**PLANNING DEPARTMENT
MAJOR SITE PLAN REVIEW
STAFF ANALYSIS**

CASE NO: 2019-0083

REQUEST: Major Site Plan Review

LOCATION: Muldoon Estates Tracts C and D

Figure 2 - Phase 2 "Core Area" as shown in the 2016 Muldoon Town Square Park Master Plan

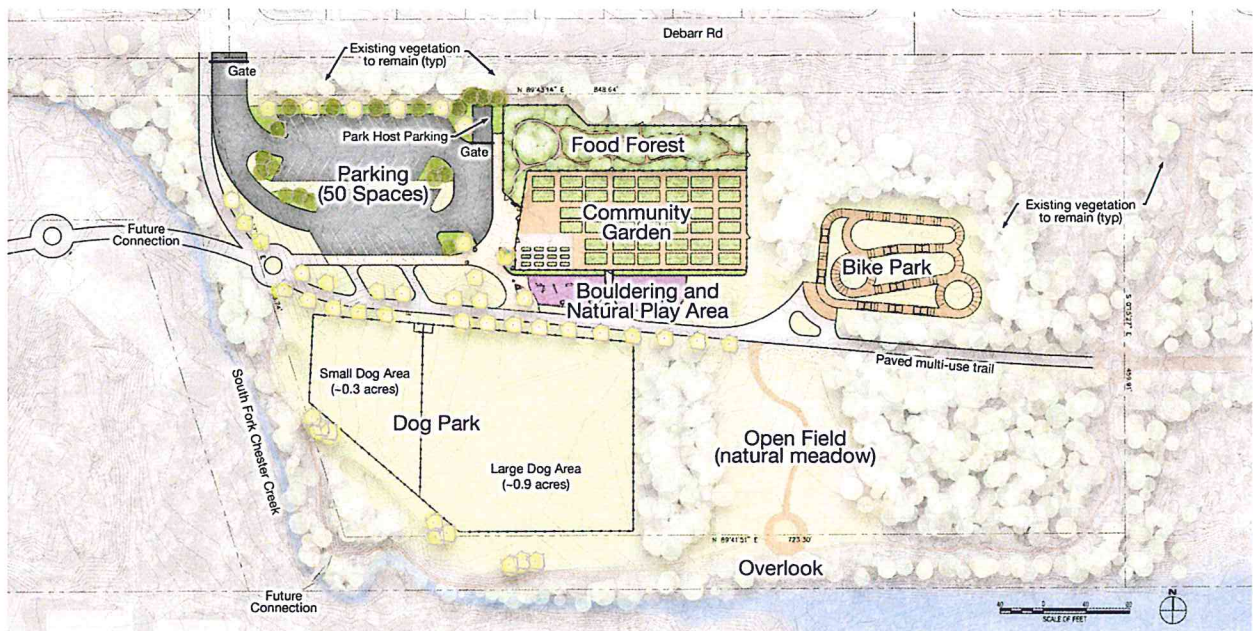
The proposed Phase 2 site plan incorporates all of the facility types outlined in the *Muldoon Town Square Park Master Plan* and does not propose any facilities that were not previously-approved. In addition, as shown in Figures 2 and 3, the design has remained substantially consistent with the 2016 *Muldoon Town Square Park Master Plan*. There are therefore no major inconsistencies with the 2016 *Muldoon Town Square Park Master Plan* per 21.05.040G.2.b.ii.B.

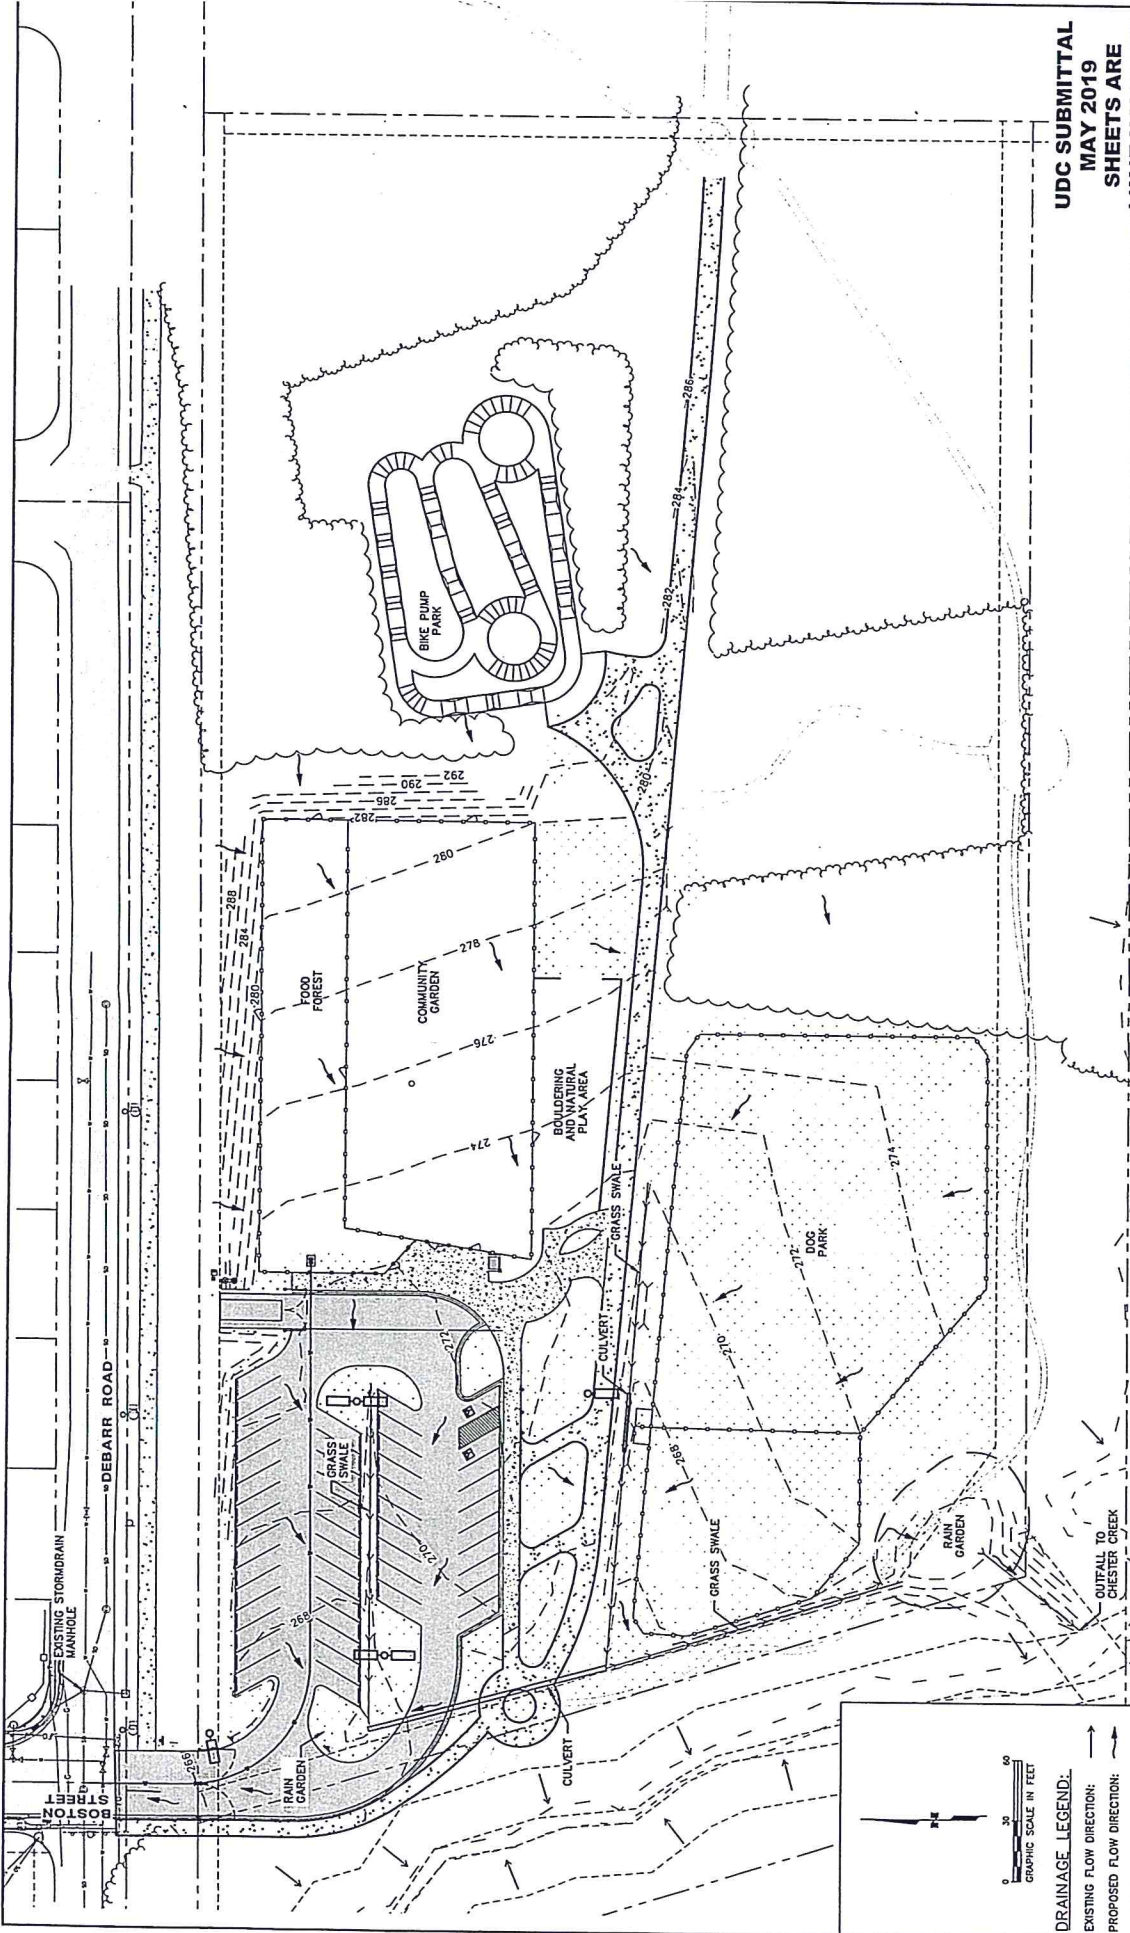
WMS raised concerns about contaminated storm water runoff from fecal matter in the proposed dog park at the southwest corner of the site. The proposed site plan shows grading that will direct runoff from the dog park through a grass swale that drains into a rain garden before discharging into the South Fork Chester Creek. This will provide natural filtration of

Departmental comments identified potential adverse impacts to the water quality of the South Fork Chester Creek storm water contamination as the primary concern resulting from the proposed site plan. The grading plan and drainage detail provided with the application show the intent to ensure that contaminated storm water from the dog park flows through swales and a rain garden prior to discharging into the South Fork Chester Creek. From the parking lot, runoff is intended to flow directly into Debarr Road and enter the wider storm water system from there. The need to ensure that contamination due to storm water runoff was identified in approval criterion 2 above, and is carried into the conditions of approval to ensure follow-up.
